## NRV 46LR COMMISSIONING

This bulletin describes in detail the extra procedures to be carried out when commissioning or revisiting NRV systems with one or more legs containing three 46LR burners, (see diagram 1). It will be necessary to change

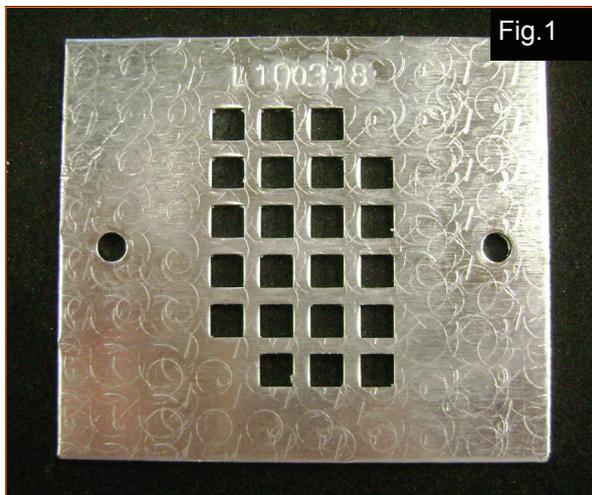
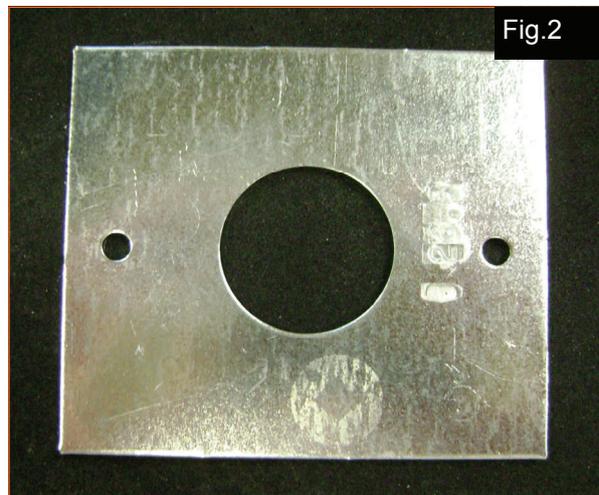
**1:** Convert each 46LR burner by changing the orifice plate from the square hole type, (if fitted), to the round hole type, (see Figs. 1 and 2).

Square hole type.

Round hole type.

Quantity	Description	Part Number
3 (per leg)	46LR orifice plate	L100318

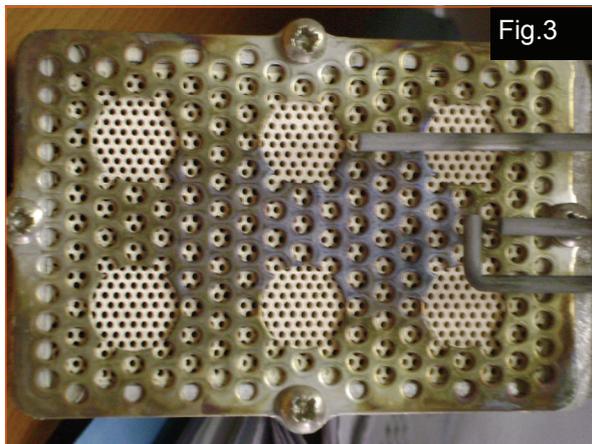
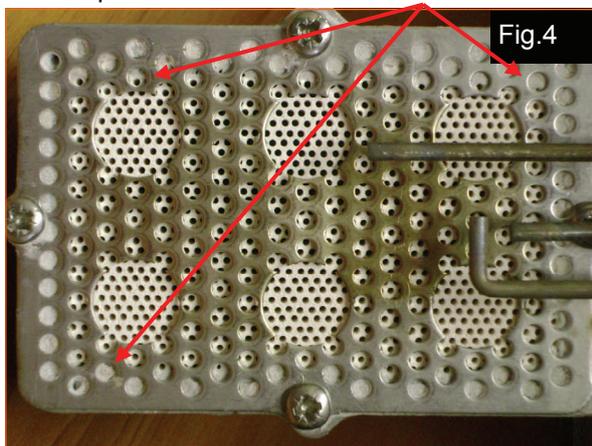
4: If the combustion readings are not satisfactory it will be necessary to remove the burner to examine the ceramic insert and the flame retention plate. (See Figs. 3 to 6).

Perimeter holes clear.

Some perimeter holes blocked with cement.

5: If the ceramic insert has any of its perimeter holes blocked with cement as shown in Fig.4, then the complete burner head should be replaced.

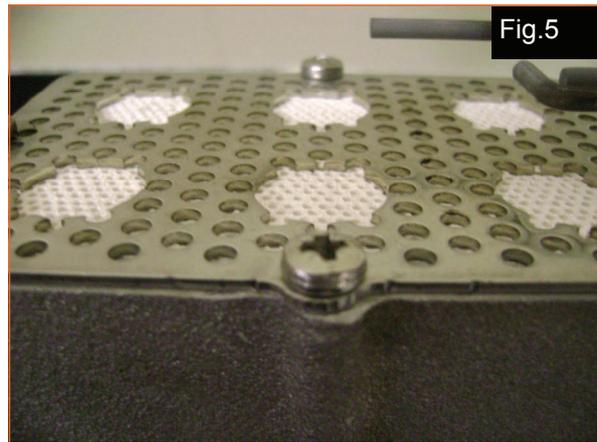
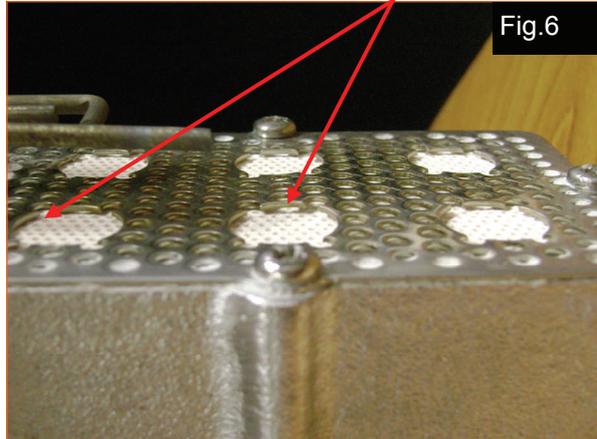
Correct flame retention plate (no gaps).

Incorrect flame retention plate.

6: If there are any gaps between the flame retention plate and the ceramic insert as shown in Fig.6, then the flame retention plate should be replaced.
